HISTORIC AND DESIGN REVIEW COMMISSION

November 03, 2021

HDRC CASE NO: 2021-543
ADDRESS: 147 E MISTLETOE
LEGAL DESCRIPTION: NCB 1704 BLK 12 LOT 24 & W 25 FT OF 25 & 27
ZONING: O-1, H
CITY COUNCIL DIST.: 1
DISTRICT: Monte Vista Historic District
APPLICANT: Morgan Penix/Adapt Architecture and Construction
OWNER: CHAMOY INVESTMENTS LLC
TYPE OF WORK: Fenestration modifications, siding replacement
APPLICATION RECEIVED: October 15, 2021
60-DAY REVIEW: Not applicable due to City Council Emergency Orders
CASE MANAGER: Rachel Rettaliata

The applicant is requesting a Certificate of Appropriateness for approval to:

2 NORTH (REAR) ELEVATION

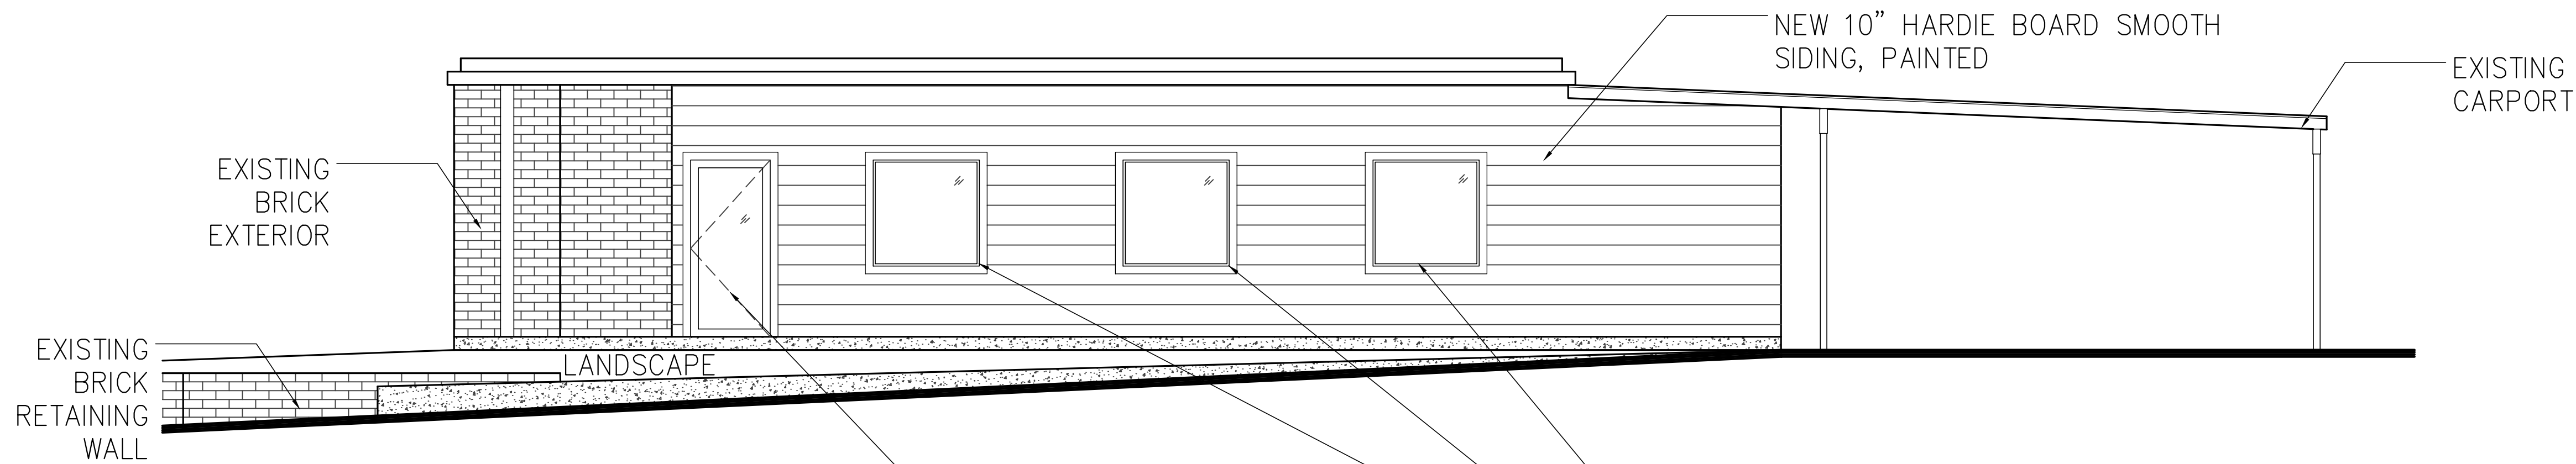
- d. NORTH ELEVATION: FENESTRATION MODIFICATION – The applicant has proposed to modify the fenestration pattern on the north elevation. The existing north elevation was previously an open carport that was enclosed. The applicant has proposed to modify the existing fenestration pattern with the installation of three (3) fixed dark bronze aluminum-clad wood windows in the center of the façade with one (1) bronze storefront aluminum full-lite door, located on the east side of the north (rear) elevation. The applicant will enclose the two existing door openings. Guideline 6.A.i for Exterior Maintenance and Alterations states that applicants should avoid creating new window openings on the primary façade or where visible from the public right-of-way. Staff finds that the modification to the non-original fenestration pattern appropriate and an improvement on the current condition. Staff finds that the applicant should submit final material specifications for the windows and door to staff for review.

- e. NORTH ELEVATION: CLADDING REPLACEMENT – The applicant has proposed to replace the existing plywood cladding on the north elevation with fiber cement lap siding. The north elevation was formerly an open carport and was previously enclosed. The existing cladding is not original to the structure. According to Guideline 1.B.i for Exterior Maintenance and Alterations, avoid removing materials that are in good condition or that can be repaired in place. Staff finds that as the existing plywood cladding is not original, and the proposed material is an improvement to the structure, the proposal is appropriate.

- i. That the applicant submits final material specifications for the new windows and doors to staff for review and approval prior to the issuance of a Certificate of Appropriateness.
- ii. That the replacement siding features a reveal of no more than 6 inches and a smooth texture.

3 WEST (SIDE) ELEVATION

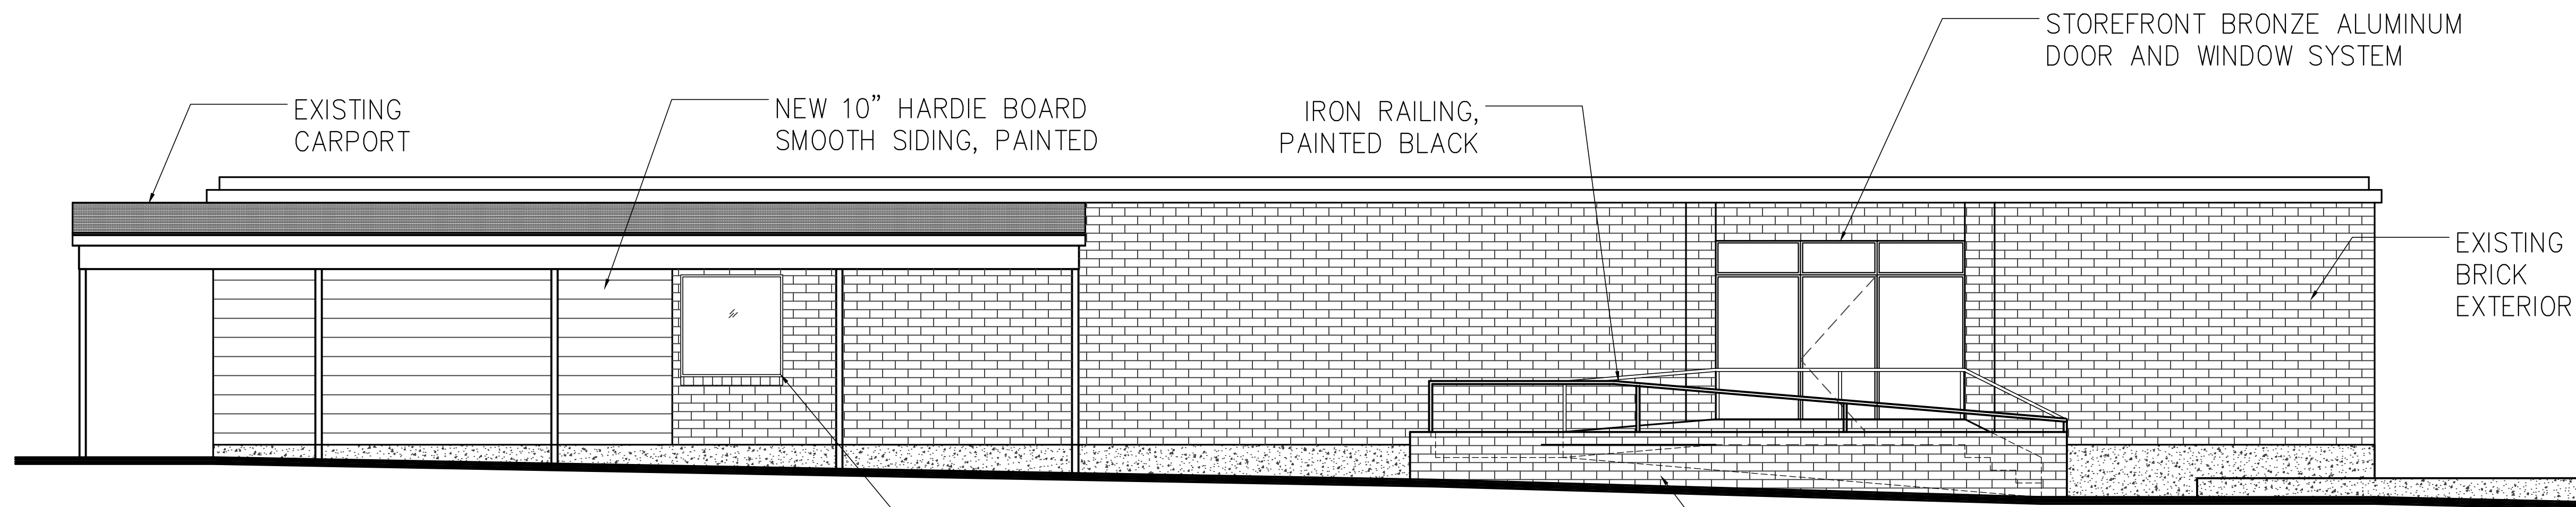
proposed to install a storefront bronze aluminum entry door and window system on the south side of the west elevation with a brick ramp with a iron railing. Guideline 6.B.ii for Exterior Maintenance and Alterations states that applicants should ensure that new entrances, when necessary to comply with other regulations, are compatible in size, scale, shape, proportion, material, and massing with historic entrances. Staff finds the proposal appropriate and that the applicant should submit final material specifications to staff for review..

- c. WEST ELEVATION : FENESTRATION MODIFICATION – The applicant has proposed to install a new window opening on the north end of the west elevation beneath the existing carport. The applicant has proposed to install a dark bronze aluminum-clad wood window. Guideline 6.A.i for Exterior Maintenance and Alterations states that applicants should avoid creating new window openings on the primary façade or where visible from the public right-of-way. Staff finds that a new window opening on the west elevation is appropriate and that the applicant should submit final material specifications to staff for review.
